Product Change Notification

Change Notification #: 118329-00
Change Title: Select Intel® Celeron® Processor N Series and Intel® Pentium® Silver Processor Series, PCN 118329-00, Product Design, Substrate 3ID Value & Placement Change

Date of Publication: June 18, 2021

(Image is for example only, showing the value moving from “5DV” to “FUA” and the location change)

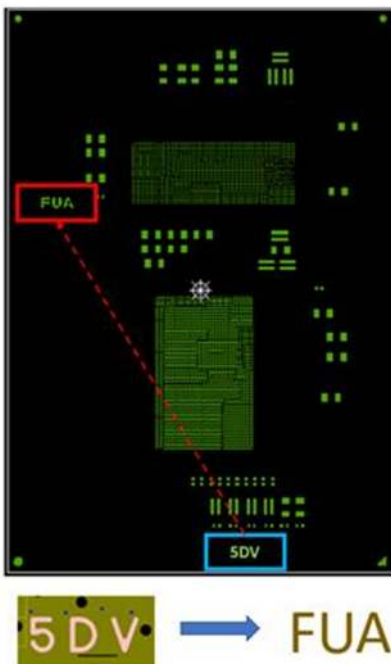
Intel is making two minor changes impacting the substrate products listed in the "Products Affected/Intel Ordering Codes" table below.

- 1) The value for the 3ID will change from 5DV to FUA.
- 2) The location for the 3ID value will move from the bottom middle of the substrate to the top left of the substrate
